ITEM:  
PLANNING COMMISSION MEETING DATE: **October 7, 2015**  
SECTION: **Land Use/Action Items**

**COBBLESTONE LAKE SOUTH SHORE 9TH ADDITION** – Consideration of the following:

SUBJECT: Cobblestone Lake South Shore 9th Addition Preliminary Plat Review

**COBBLESTONE LAKE SOUTH SHORE 9TH ADDITION**  
 PRELIMINARY PLAT  
 APPLE VALLEY, MINNESOTA  
 SOUTH SHORE DEVELOPMENT, INC.  
 16972 BRANFORD FARM DRIVE, LAKESIDE, MN 55044

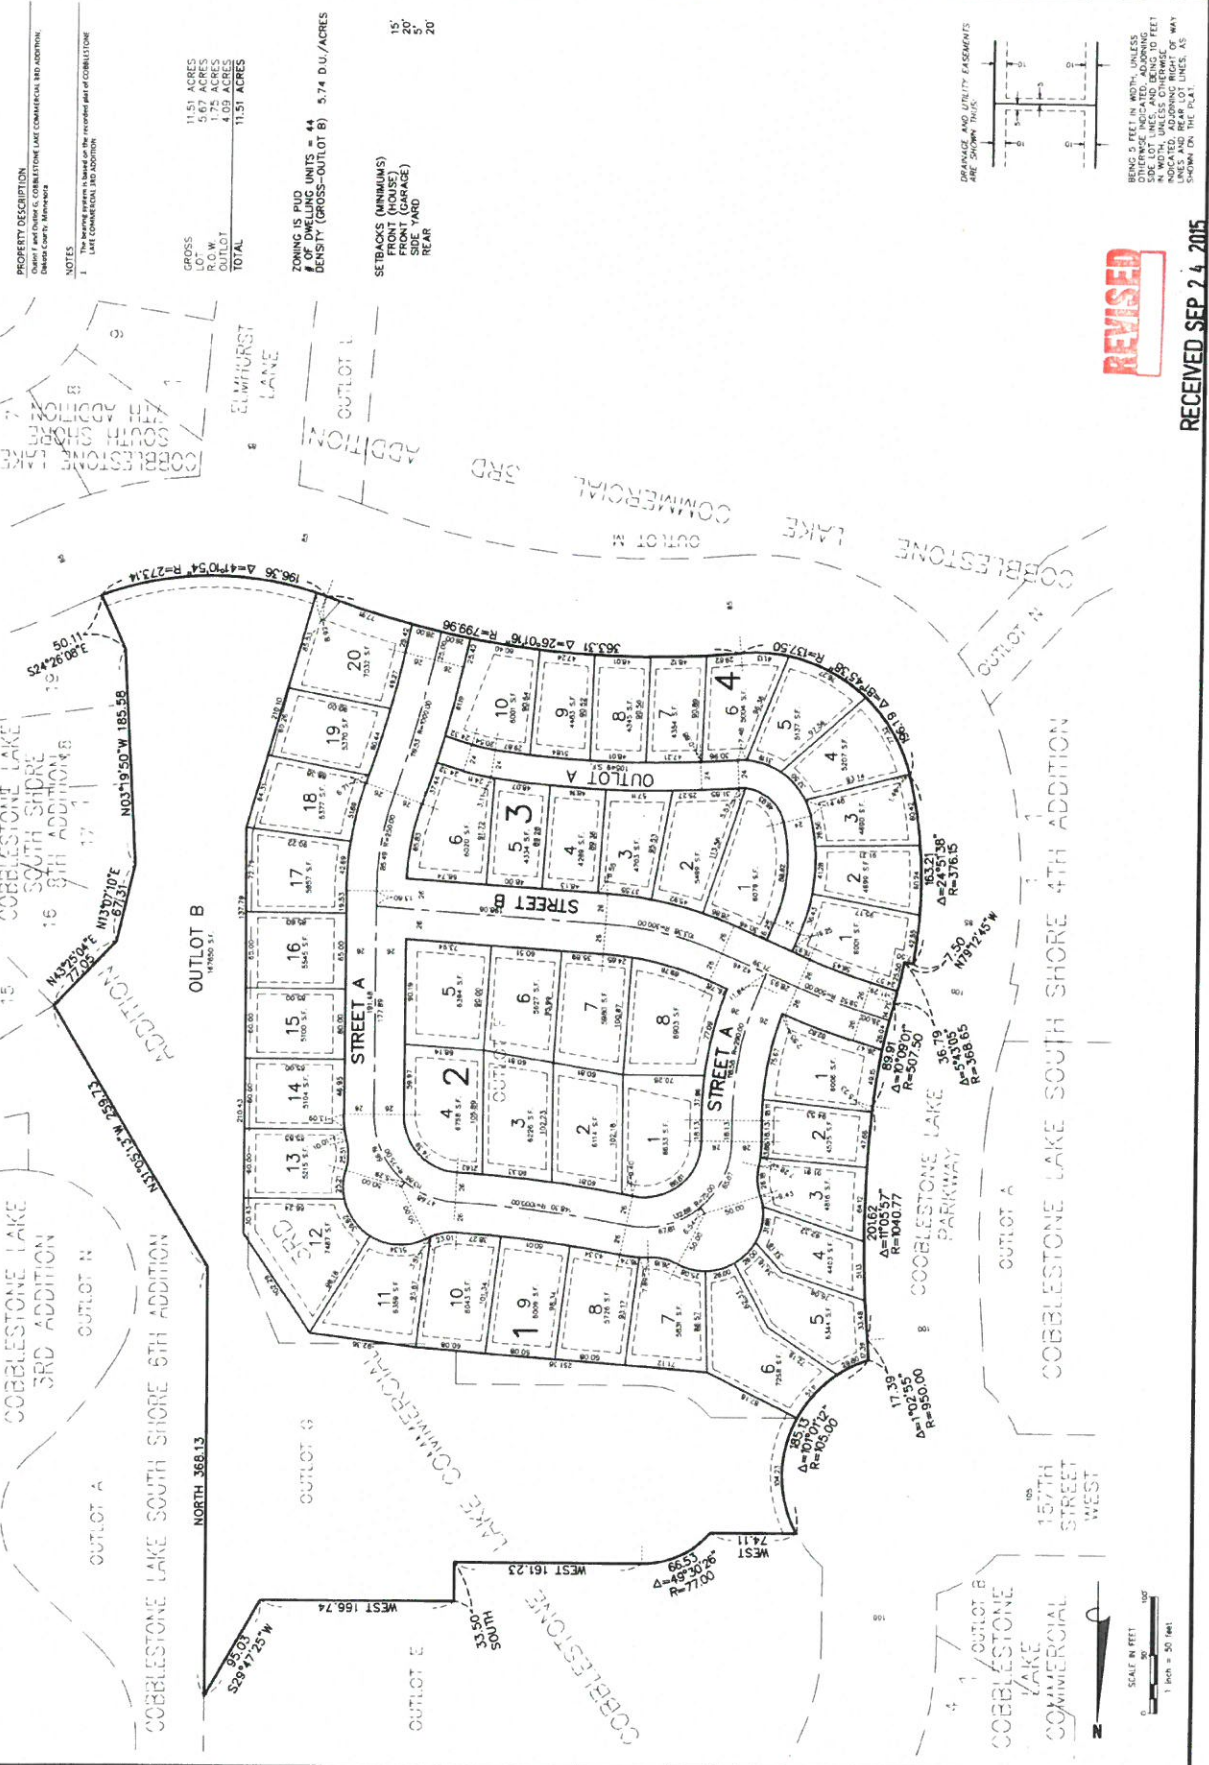
**Preliminary Plat:** The preliminary plat, which encompasses approximately 11.51 acres, is currently platted as two outlots (Outlot F and G, COBBLESTONE LAKE COMMERCIAL 3RD ADDITION). The petitioner is proposing to plat the majority of Outlot F and a small area of Outlot G into 44 single-family lots, one outlot that will be a private drive and public street right-of-way. The remainder of the property not contained within Blocks 1-4 and Outlot A will be platted as an outlot and will be used for public park purposes, of which nearly all of the proposed Outlot B is currently part of Cobblestone Lake Park.

The portion of Outlot F, north of proposed Lots 6-10, Block 1 should be platted into those lots and this area should be used for berming and landscaping.

- Sanitary sewer and water main at Street A and Cobblestone Lake Parkway South shall be modified to provide 10 feet of separation from the storm sewer.
- Sanitary manhole MH-4 may be required to extend further north to provide service to Lot 13, Block 1.

- Pavement section for median cut shall match existing Cobblestone Lake Parkway S.
- Easements shall be adjusted for future trail and sidewalk connections.
- Street C is indicated to be private.
- Outlot A shall be dedicated as drainage and utility easement for future access to public utilities.
- It is recommended that the rear property line for Lots 6-12 of Block 1 be revised to include the area of the existing property line adjacent to the park. This area shall be utilized for berms and landscape screening from future park parking lot.

- Sanitary sewer and water main at Street A and Cobblestone Lake Parkway shall be modified to provide 10' separation from storm sewer.
- Sanitary MH-4 may be required to extend further north to provide service to Lot 13.

- The section of property located north of Lots 6-10, Block 1, currently contained in Outlot F, shall be excluded.
4. Recommend approval of the COBBLESTONE LAKE SOUTH SHORE 9TH ADDITION preliminary plat, subject to the following conditions:

- The plat shall be configured to have 44 residential lots and two outlots.
  - Outlot B shall be dedicated for public park purposes.
  - The dedication on the final plat of draining and utility easements within the
